GOVERNMENT OF THE DISTRICT OF COLUMBIA
DEPARTMENT OF TRANSPORTATION

MEMORANDUM

SUBJECT: **BZA Case No. 19026** – 1300 H Street, NE

Figure 1 Site Design and Access (Source: Grove/Slade)

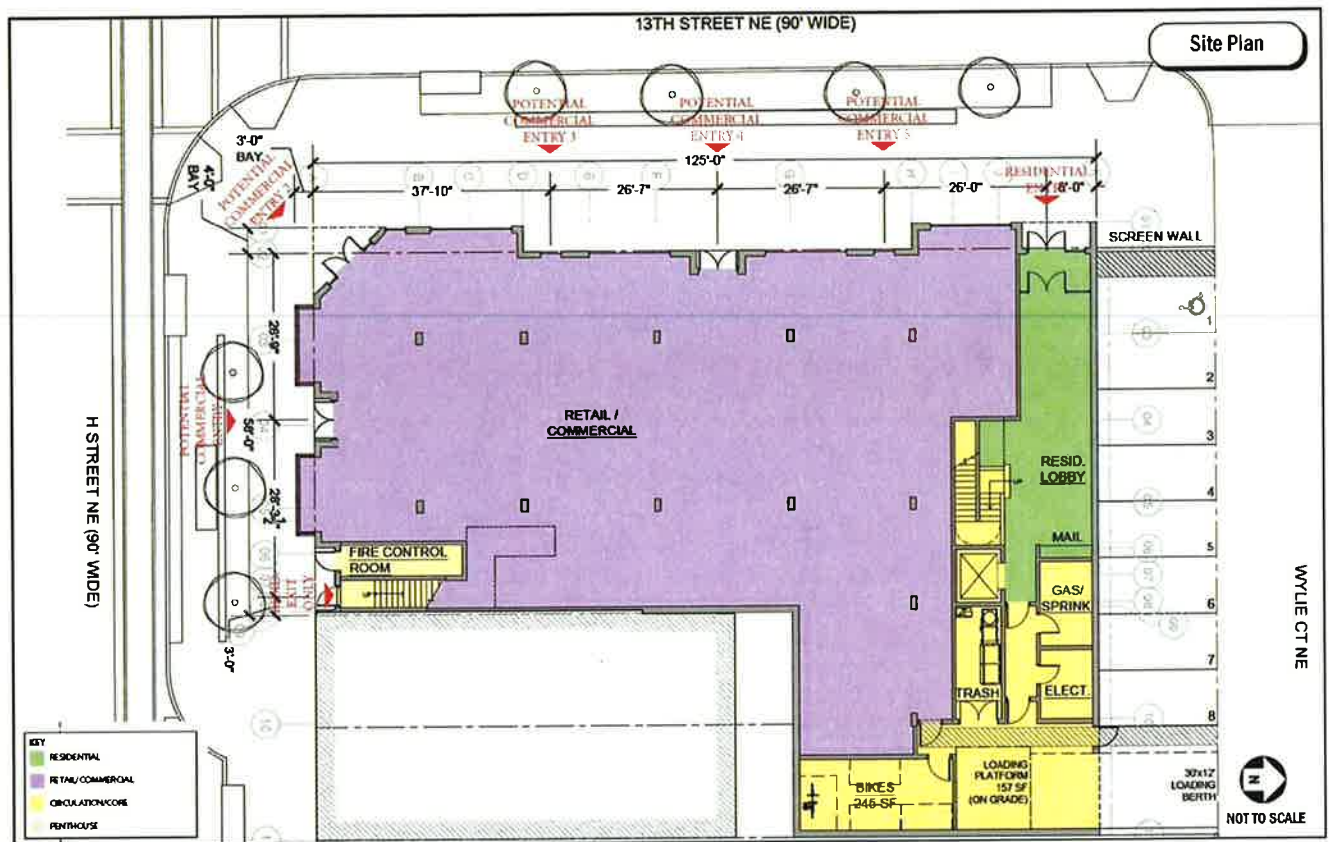
Site plans do not include the existing 26-dock Capital Bikeshare station adjacent to the site. The location of the existing bikeshare station will be coordinated during the public space permitting process. DDOT expects the bikeshare station to remain on 13th Street adjacent to the site and will not interfere with the clear pedestrian path nor require the removal of any street trees. DDOT does not support moving the station to another location because it is difficult to place a 26-dock station within the H Street Corridor, DDOT plans on expanding the bikeshare network, not removing or moving stations, and the existing station is located equidistant from two other stations. As such, DDOT anticipates that the commercial entrance on 13th may need to be moved to ensure the bikeshare station remains adjacent to the site.

As previously noted, the existing bikeshare station will be required to remain adjacent to the site on 13th Street. The bikeshare station's placement will not be permitted to interfere with the clear pedestrian path nor require the removal of any street trees.

Figure 3 Weekday Parking Occupancy (Source: Grove/Slade)

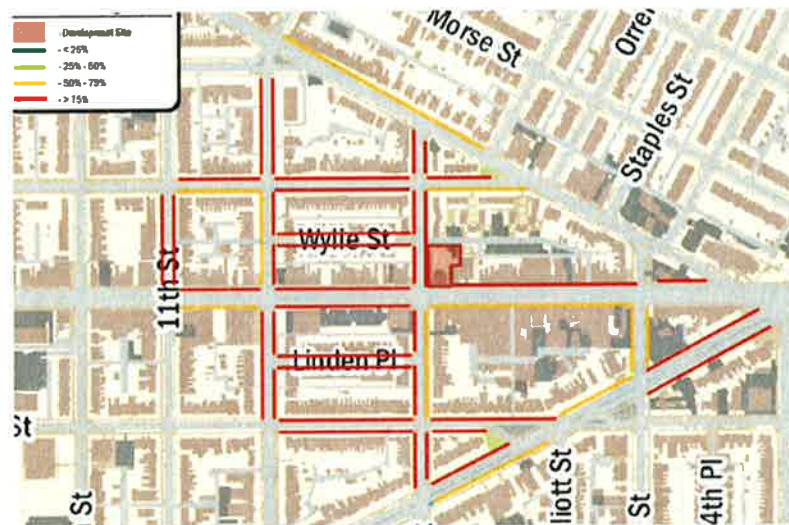
The proposed site includes eight surface parking spaces. Zoning requires the provision of 30 parking spaces, 18 spaces for residential use and 12 spaces for retail use. The projected trip generation for the site expects 11 auto-based trips originating in the AM and 17 in the PM peak hour, illustrating the relatively low amount of parking turnover. Parking occupancy data was collected on Thursday, May 28, 2015 and Friday, May 29, 2015 both from 4:00pm to 10:00pm, when parking demand is at its peak for the area. This analysis shows unused nearby street parking that would meet the proposed project's parking demand, with 97 spaces available during peak weekday demand (9:00 pm to 10:00 pm) and 43 spaces available during peak weekend demand (10:00 pm to 11:00 pm). While parking utilization is relatively high during both weekday and weekend peak parking demand periods (see Figures 2, 3, and 4), DDOT finds that the available parking spaces should accommodate the expected peak hour site generated vehicular trips. Additionally, three carsharing locations can be found nearby with a total of seven vehicles.
